SERVICE INFORMATION NO. SI 20E-010

EASA Emergency Airworthiness Directive No. EAD 2019-0253-E Engine fuel and Control – Fuel Pump Assembly – Replacement

Rotax Alert Service Bulletin No. ASB-912 i-011, Replacement of Fuel Pump Assy for Engine Types 912 i and 915 i A (Series)

Replacement of fuel pump assy. for ROTAX® Aircraft Engine Type 915 i A and 912 i (Series)

Fig. 1

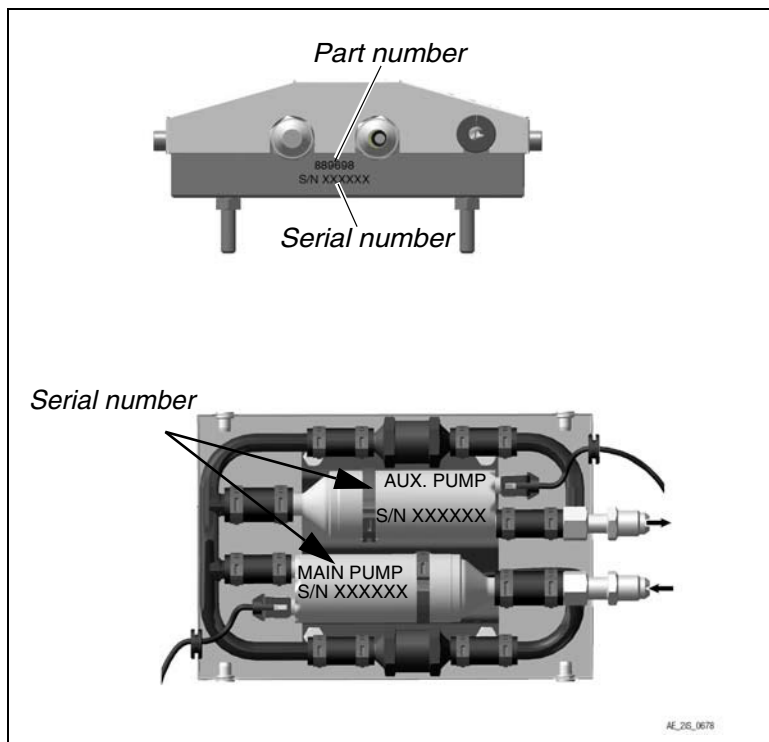
See Fig. 1 on information how to find the part no. and S/N on the fuel pump assy.
